RE: DOE FEMP
COMMENTS: DRAFT FINAL
BRSR FOR THE ARP
APPROVAL: RAWP FOR ARP

This letter provides as an attachment Ohio Environmental Protection Agency comments on the draft final Baseline Remedial Strategy Report for the Aquifer Restoration Project. This letter also serves as Ohio EPA approval of the Remedial Action Work Plan for the Aquifer Restoration Project.

Ohio Environmental Protection Agency Comments on the draft final
Baseline Remedial Strategy Report for the Aquifer Restoration Project

Figure 1. Concepts of contaminant sorption onto aquifer media.

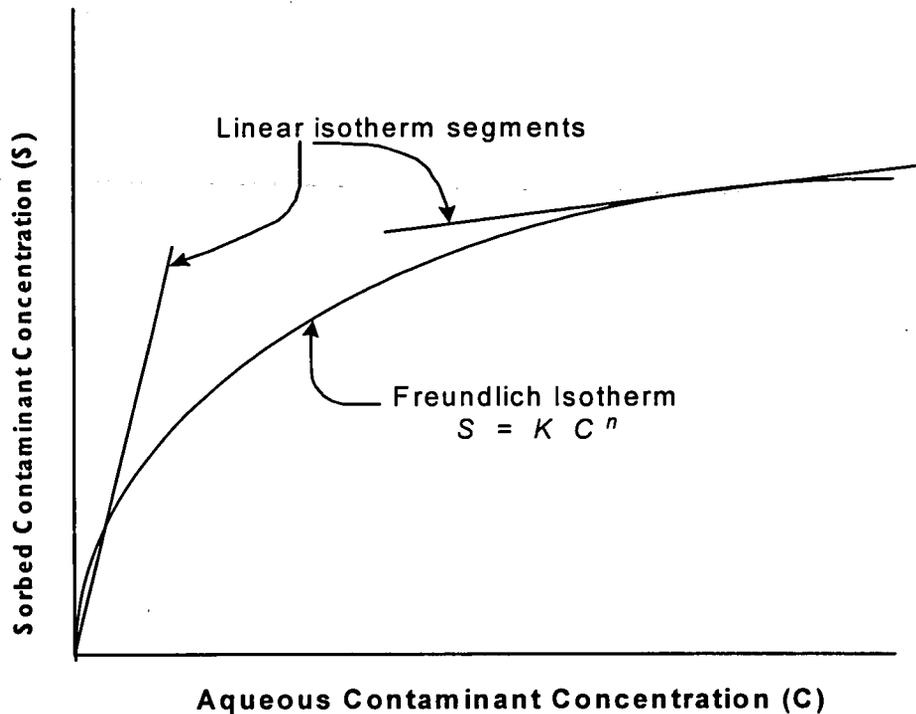
A mathematically rigorous approach for modeling continuously changing sorption behavior is to use a nonlinear isotherm, such as the Freundlich isotherm (Freeze and Cherry, 1979; Schwarzenbach, 1993). Instead of using the two sorption regimes (represented by the two K_d values corresponding to only two points on a curve), a continuous mathematical function describes the entire range of sorption behavior expected during the plume recovery, as shown in Figure 1. Available groundwater flow and transport models (e.g., SWIFT, FTWORK) provide the capability of utilizing the Freundlich isotherm. The two parameters required for the Freundlich isotherm (K, n) can be estimated from the Feasibility Study batch sorption data (DOE, 1995). Alternatively, these parameter values for a wide range of contaminants are available in the literature.

Because the effect of sorption on duration of cleanup to FRL has been shown to be very significant, DOE should consider using Freundlich isotherm for more realistic predictions. This approach will simplify the modeling procedures used in the BRSR (Appendix A) and reduce overall uncertainty, particularly the uncertainty associated with guessing the appropriate time for switching from one K_d regime to another.

Comparison of Remediation Scenarios

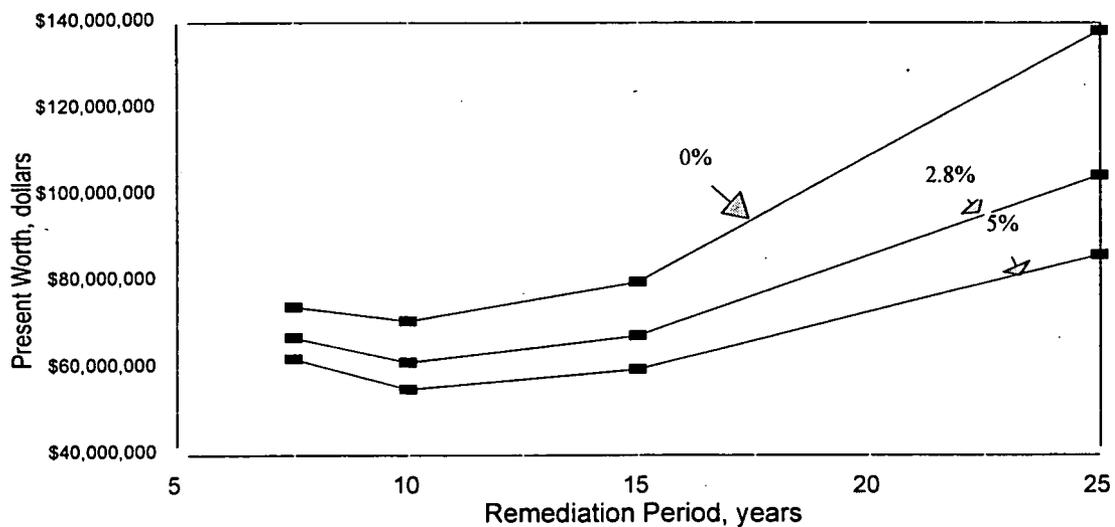
- 54) Commenting Organization: OEPA Commentor: HSI GeoTrans, Inc.
 Section #: Table 4-11 Summary of Present Worth Analysis Page #: 4-30 Code: C
 Comment: It would be better to present the data in Table 4-11 as a graph, similar to the one below. The data used in this graph are from the cost estimates we compiled using DOE's scenarios and unit costs, however we converted future costs to present

costs for all wells installed in the future. From this graph, two things become apparent. The 10-year scenario is the most cost effective (as DOE has established) and secondly, the difference in present worth costs diminishes significantly as the discount rate changes from 0% to 5%. This should be discussed in the text.
